ADDENDUM NO. 1 TO PROJECT NO. 45832

**CONSTRUCTION, ELEVATOR, HVAC, PLUMBING, AND ELECTRICAL WORK
REHABILITATE ELEVATORS
CULTURAL EDUCATION CENTER
EMPIRE STATE PLAZA
ALBANY, NY**

April 05, 2024

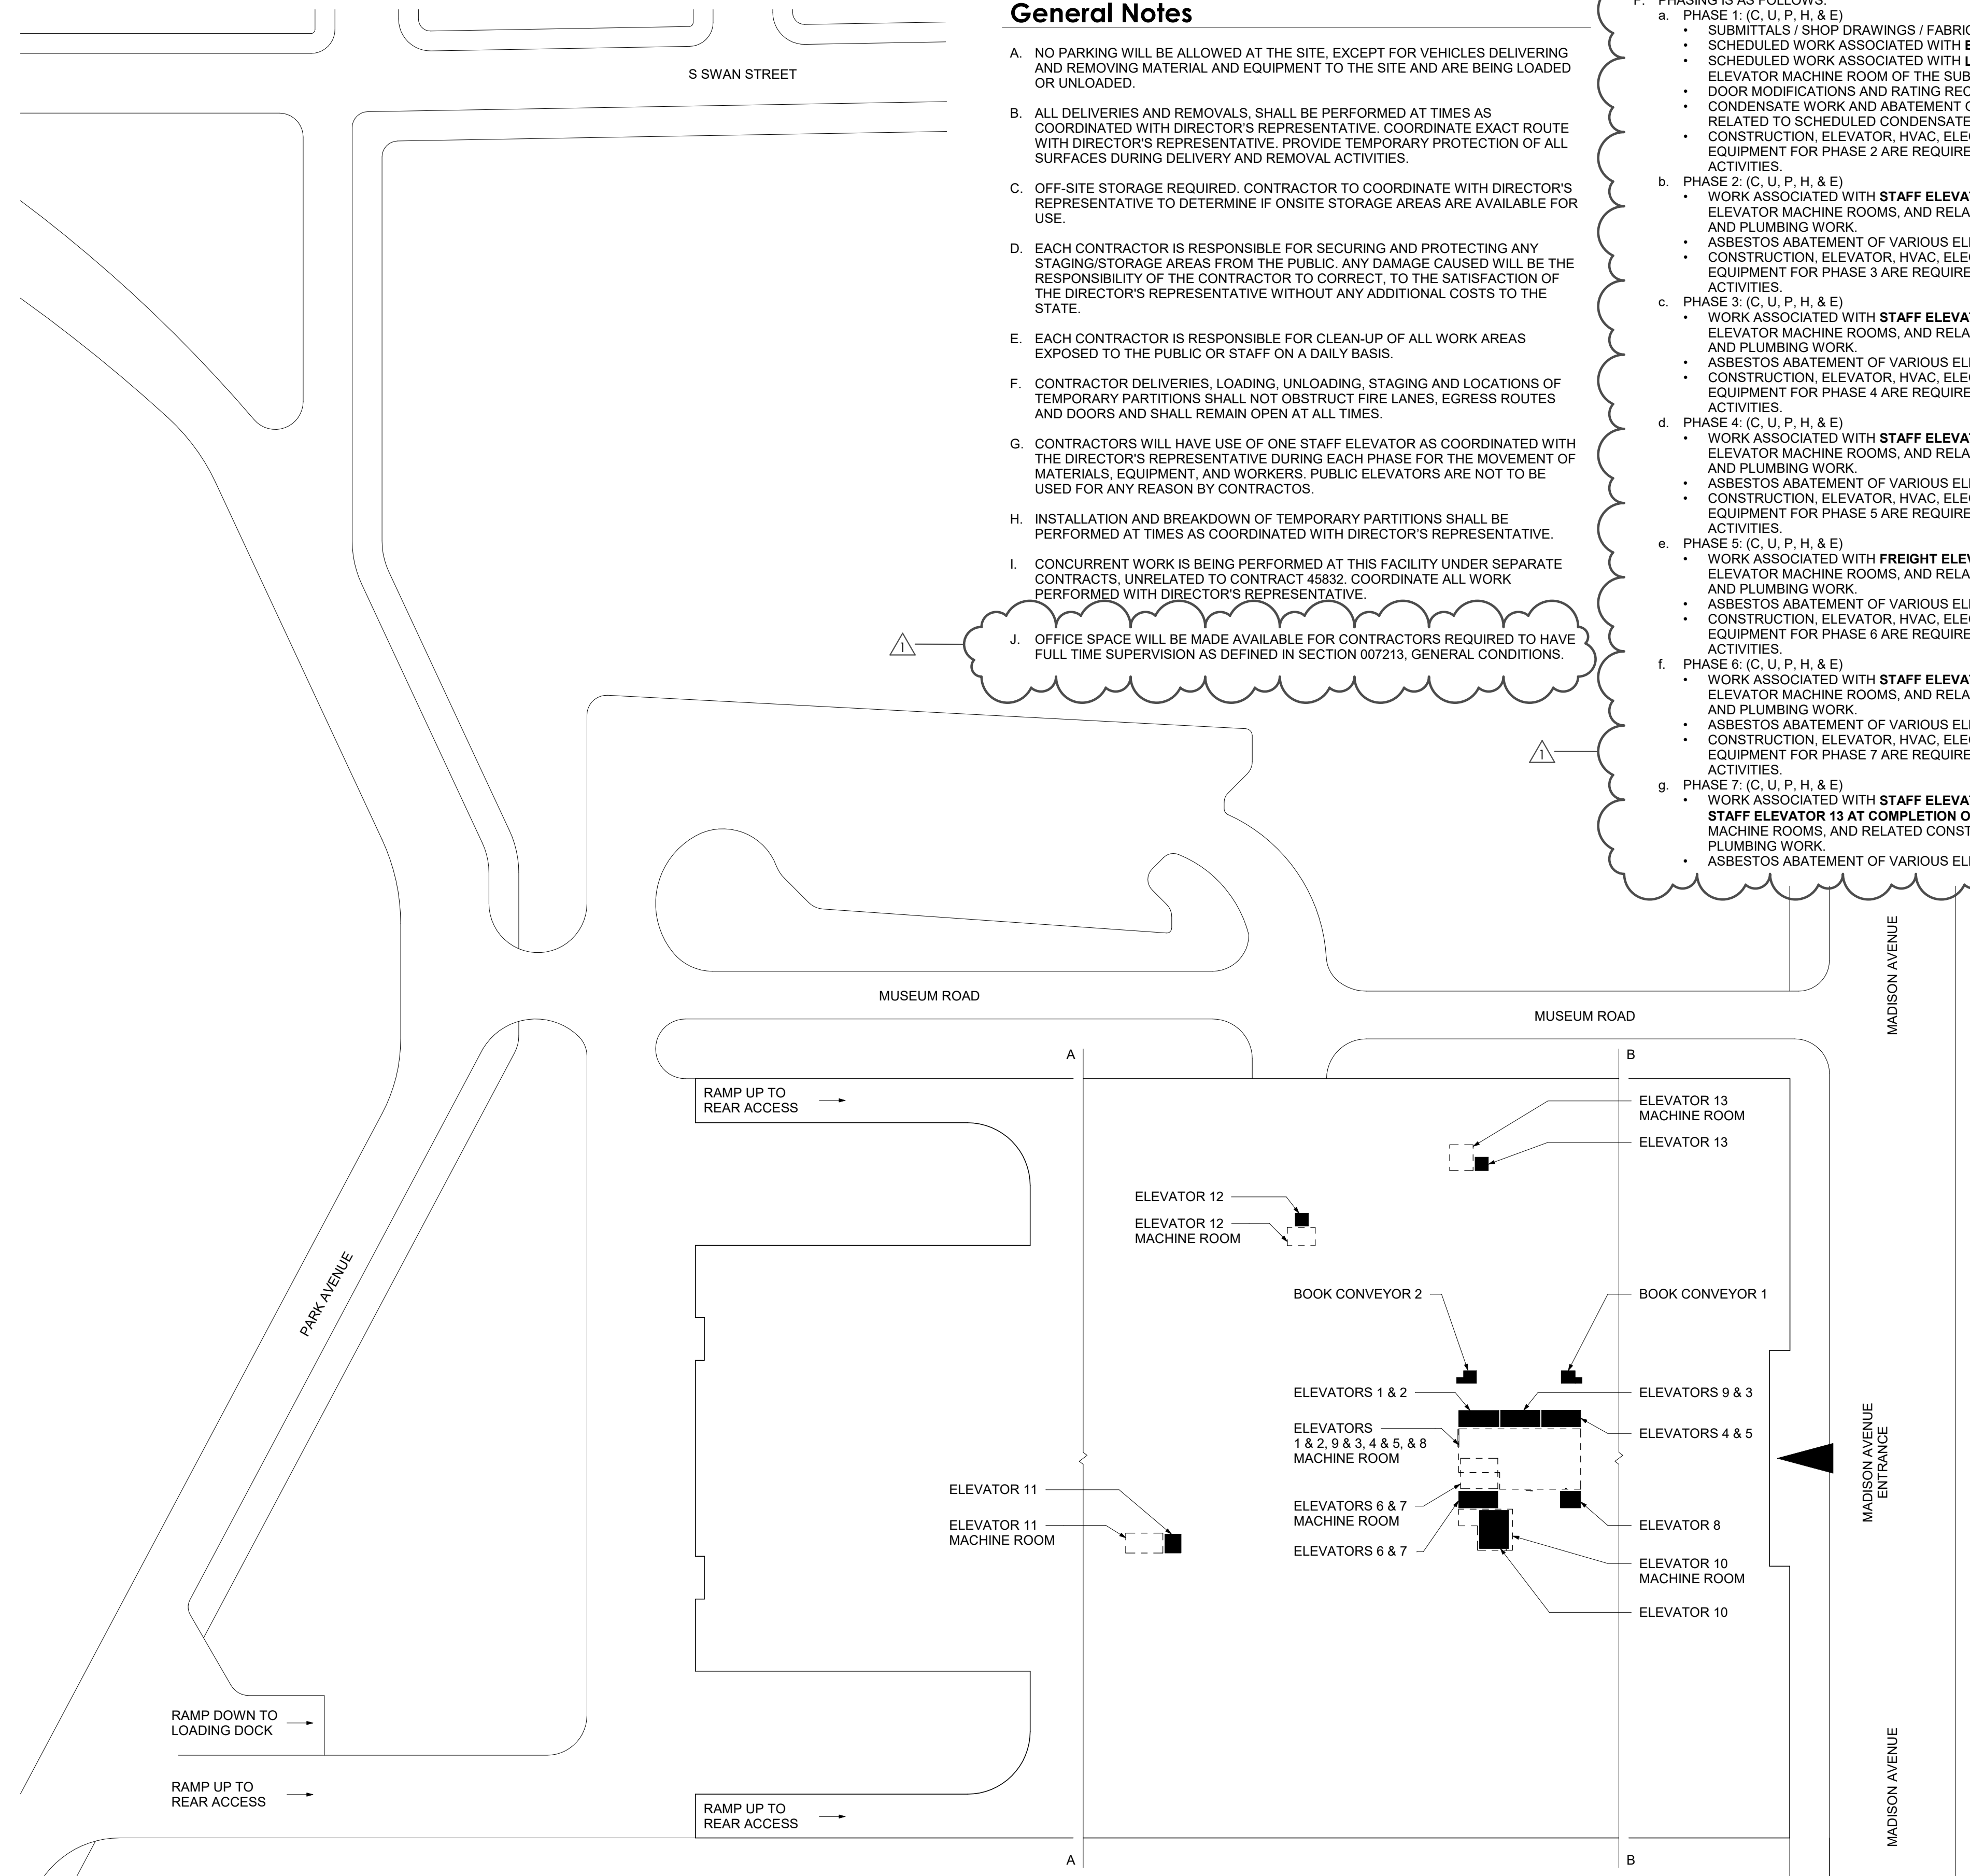
7. Drawing No. S-102:
a. Detail No. 9; Elevator Pit Structure Plan – Elevator 13: Change detail callout “10/S-102 SIM” to read, “11/S-102 SIM”.
8. Revised Drawings:
a. Drawing No. G-101 and H-102, noted “REVISED DRAWING 4/5/2024” accompany this Addendum and supersede the same numbered originally issued drawings.
